UNITED STATES PATENT AND TRADEMARK OFFICE

APPLICATION NO.	FILING DATE	FIRST NAMED INVENTOR	ATTORNEY DOCKET NO.	CONFIRMATION NO.
10/776,522	02/12/2004	Yohei Makuta	0505-1268P	4129

Office Action Summary	Application No. 10/776,522	Applicant(s) MAKUTA, YOHEI	
	Examiner BRUK A. GEBREMICHAEL	Art Unit 3715

DETAILED ACTION

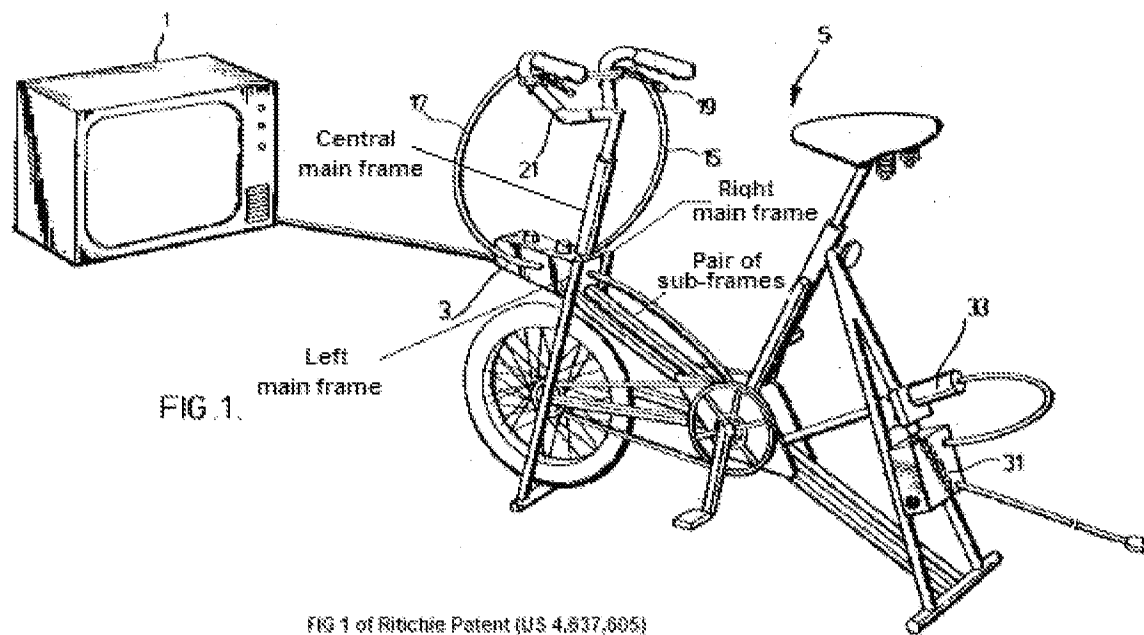
However, Ritchie teaches, a pair of left and right main frames, a centrally located main frame a pair of sub-frames connected to roughly central portions of the right and left main frames (see Examiner's annotated figure, FIG A which is based on FIG 1 of Ritchie's apparatus, label Pair of sub-frames), and a control unit for the system being mounted between the pair of left and right main frames and under the centrally located main frame (FIG 1, label 3 and also see FIG A regarding the Examiner's interpretation).

Ritchie further teaches, the casing of the control unit is disposed between a first main frame and a second main frame (see FIG A below with the Examiner's interpretation)

However, Ritchie teaches, a pair of left and right main frames, a centrally located main frame a pair of sub-frames connected to roughly central portions of the right and left main frames (see Examiner's annotated figure, FIG A which is based on FIG 1 of Ritchie's apparatus, label Pair of sub-frames), and a control unit for the system being mounted between the pair of main frames (FIG 1, label 3 and also see FIG A regarding the Examiner's interpretation).

However, Ritchie teaches, the end of the centrally located main frame is connected to a cross frame bridging between tip end portions of the sub-frames (see FIG A, the section i.e. wall of the control unit where the end of the pair of sub- frames and end of the central frame are connected).

Regarding claims 20 and 21, Caprai in view of Ritchie teaches the claimed limitations as discussed above. Ritchie further teaches, a cylinder portion for receiving a steering stem, and wherein each of the right, left, and centrally located main frames has an upper end connected to the cylindrical portion (see FIG A below with the examiner's interpretation, the central frame, and the left and right main frames).

- In response to argument (2), the Examiner respectfully disagrees. As already presented in the previous office action, and also in this current office action, the control unit taught by Ritchie (FIG 1, label 3) is attached to a cross frame where the end of the pair of sub-frames and the end of the central frame are connected. Regarding the limitation "wherein a front face of the control unit faces the rear side of the cross frame",
